Country Breeze Subdivision, Resubdivision of Lots 1, 2 and 5, Resubdivision of Lots 1 and 5

APPLICATION NUMBER 2 DATE December 7, 2006
APPLICANT Country Breeze Subdivision, Resubdivision of Lots 1, 2, and 5,
Resubdivision of Lots 1 and 5
REQUEST Subdivision

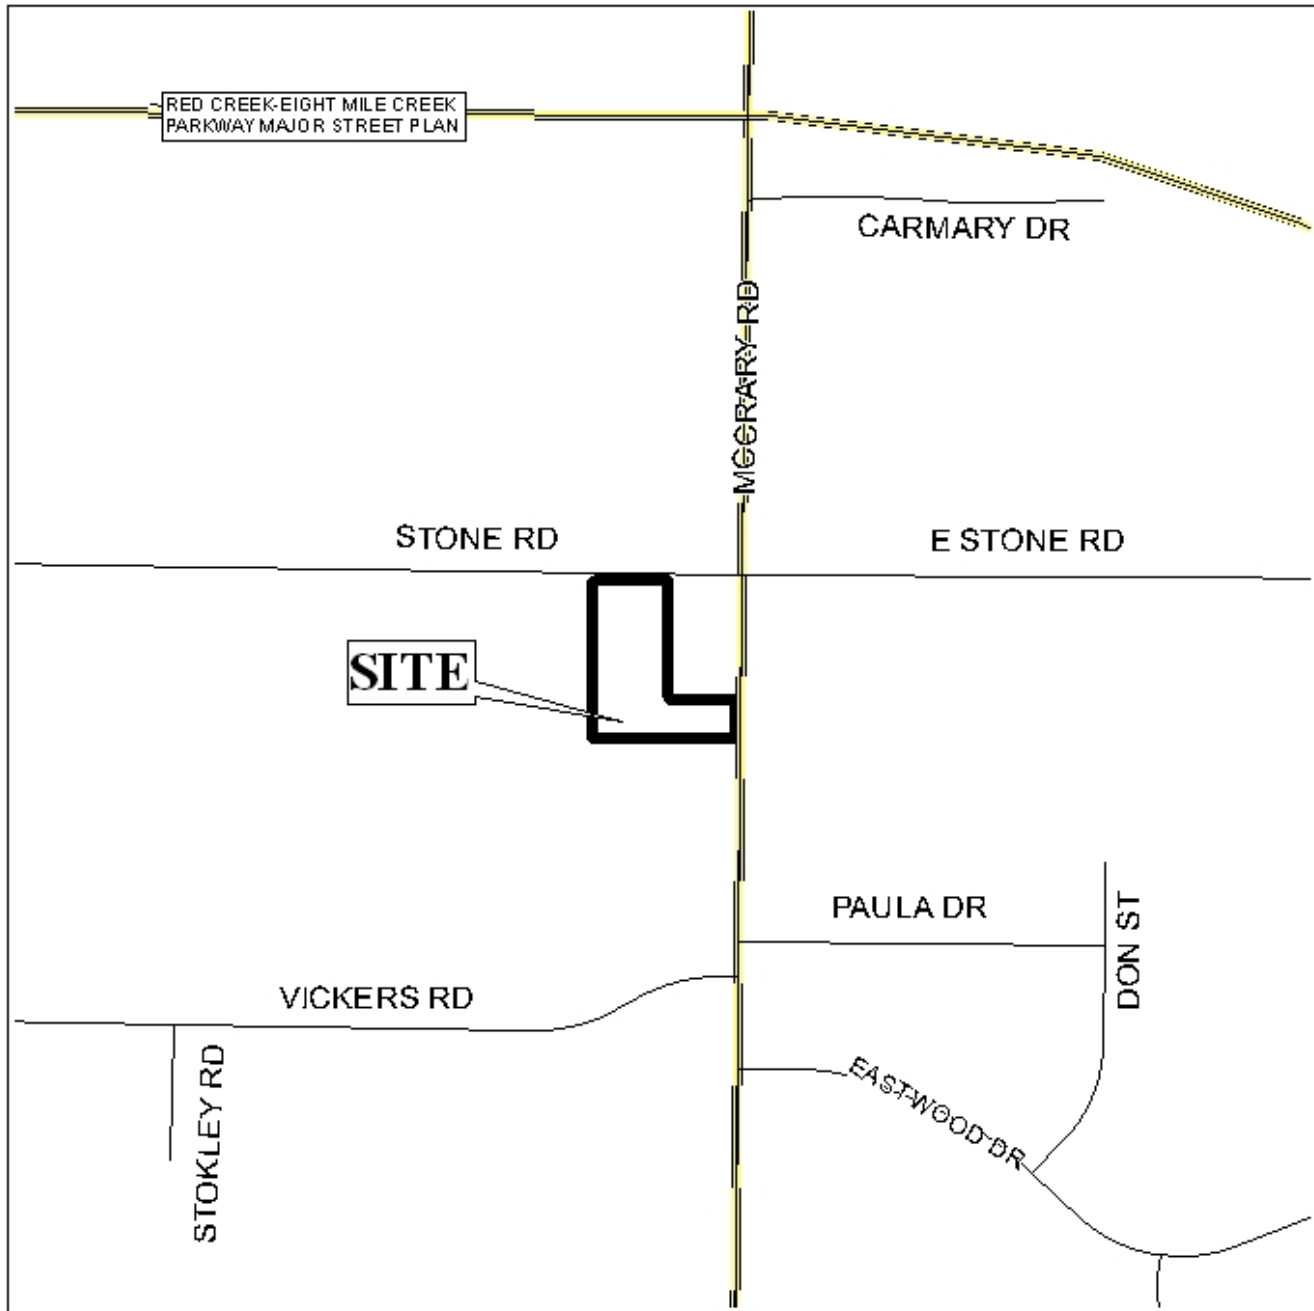
The purpose of the application is to move an interior lot line between two existing lots of record (1 and 5), removing a 25-foot drainage access to McCrary Road from Lot 1 that was created by the previous subdivision application that was approved by the Planning Commission at its April 6, 2006 meeting.

The site fronts McCrary Road, which has an 80-foot right-of-way; as required by previous approvals, the plat illustrates a 75-foot setback from the centerline to provide for the building setback from the major street right-of-way. The site also fronts Stone Road, which has a 60-foot right-of-way.

Per the previous approvals, curb-cuts should be limited in order reduce potential vehicular conflicts. A note should be placed on the final plat stating that lot 1A is limited to one curb-cut onto Stone Road, and lot 2A is limited to one curb-cut onto McCrary Road, with the size, location, and design to be approved by the Mobile County Engineering Department.

Stormwater facilities are not depicted on the plat, however, compliance with the City of Mobile stormwater and flood control ordinances will be required. A letter from a licensed engineer certifying compliance with the City's stormwater and flood control ordinances should be submitted to the Mobile County Engineering Department prior to the issuance of permits for site work, new building construction or building expansion.

The plat meets the minimum requirements of the Subdivision Regulations and is recommended for Tentative Approval, subject to the following conditions: 1) the depiction of the 75-foot setback from the centerline of McCrary Road and the 25-foot setback from Stone Road, as shown on the plat; 2) the placement of a note on the final plat stating that lots 1A and 5A are limited to one curb-cut each, with the size, location, and design of all curb-cuts subject to Mobile County Engineering Department approval; 3) revision of the plat to label each lot with its size in square feet, or provision of a table on the plat depicting the same information; 4) placement of a note on the plat stating that a letter from a licensed engineer certifying compliance with the City's stormwater and flood control ordinances must be submitted to the Mobile County Engineering Department prior to the issuance of permits for site work, new building construction or building expansion; and 5) the placement of a note on the final plat stating that any lots that are developed commercially and adjoin residentially developed property must provide a buffer, in compliance with Section V.A.7 of the Subdivision Regulations.
